Saddleback Ridge Wind, LLC // Natural Resource Protection Act (NRPA) and Site Location of Development Act applications

- Licensee Exhibit 11
Review of Saddleback Ridge Wind Project Visual Quality and Scenic Character Report (“MLA Report”) by James F. Palmer (January 21, 2011)

Review of Saddleback Ridge Wind Project, Carthage, Maine: Wind Facility-Visual Quality and Scenic Character Report

James F. Palmer
Scenic Quality Consultants

Figure 1. A view of the Webb Lake "Beach" at Mount Blue SP, and a view from the northern most extent of the beach toward Saddleback Mountain. The project will be screened by the trees at the southern end of the "Beach."

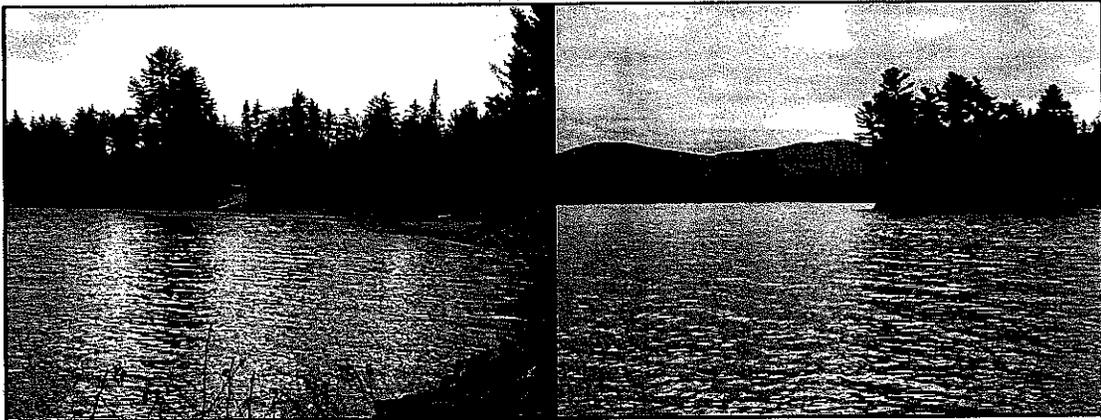
- Page 3. The photograph on this page may be from the shoreline within Mount Blue State Park's boundaries, but it is not at the area known as the "Beach." The "Beach" is a relatively discrete developed area within the park, and there is no possibility that the turbines will be seen from the beach, as shown in the photo on page 24 on MLA's report and in Figure 1 below. On page 24, MLA acknowledges that much of what is he calls Webb Beach is a "rocky shoreline." The "Beach" is likely the place of greatest visitor density in the park, while the "rocky shoreline" at the northern end of the park may see very few people. The viewpoint MLA says is from "Mount Blue State Park Beach" needs to be accurately located and characterized.

Figure 2. Views from the rocky shoreline north of the “Beach” toward Saddleback Mountain. The project will not be visible in the view on the left, and two or perhaps three turbines will be visible in the view on the right.

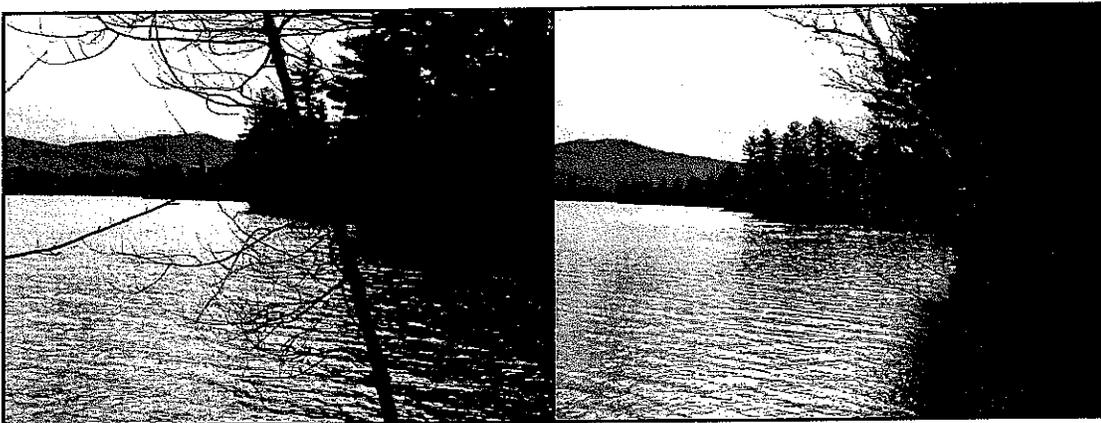
Page 26. “Moving north [from the “Beach”], the towers become apparent, one after the next until all twelve towers will become visible in the area adjacent to the campground.” MLA makes it sound like the rocky shoreline north of the beach is an open continuous stretch with an unobstructed view toward the project. My experience on the site was different. Walking north on the trail from the “Beach” I encountered a forested shore that made clear views to the southeast difficult—the view on the right side of Figure 2 required climbing onto a boulder in the water. The natural direction for viewers to look is across the lake to the residences. While some views toward the project do exist, they are not the continuous open views suggested by a beach location.
